2014 - 2018 Corvette: Service Bulletin: #PIP5248D: Stalling Shudder And/or Hard shifting Into 1st Gear Or Reverse Vibration On launch

#PIP5248D: Stalling Shudder And/or Hard shifting Into 1st Gear Or Reverse Vibration On launch (With Excessive Crankshaft End Play) - (Aug 10, 2017)

This PI was superseded to update Models. Please discard PIP5248C.

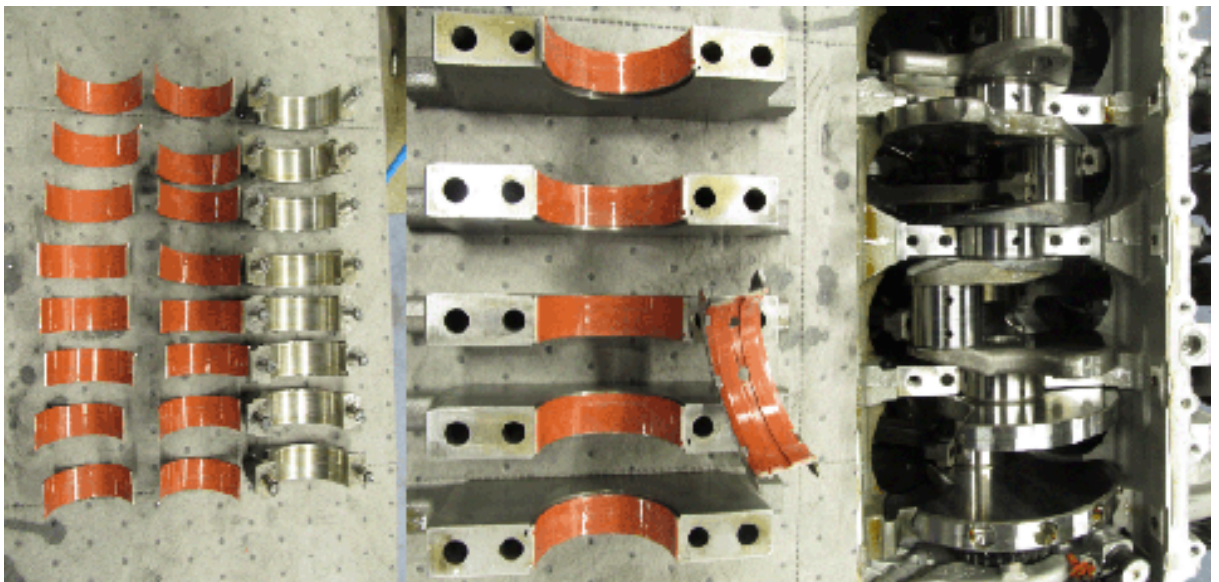
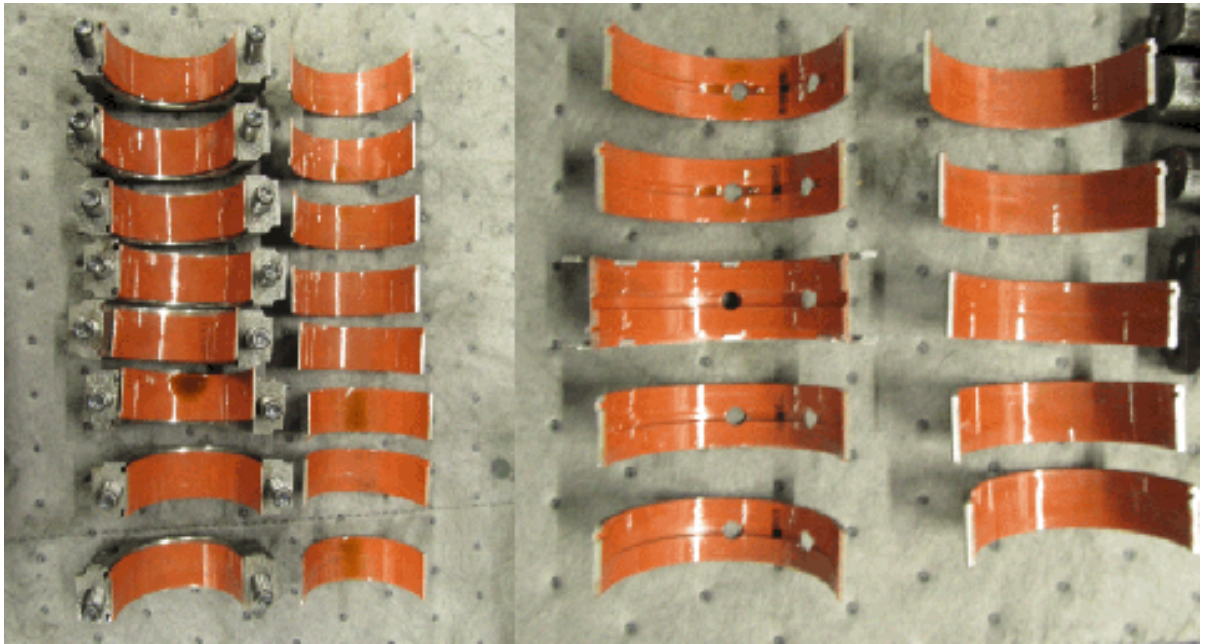
Note: If bearings and crankshaft look like components in attached picture, damage has not occurred.

Inspect thrust bearing for wear on one side and crankshaft on that “mating” surface.

If wear is evident (3 vertical channels worn off) replace connecting rod bearings, main bearings, thrust bearing and crankshaft.
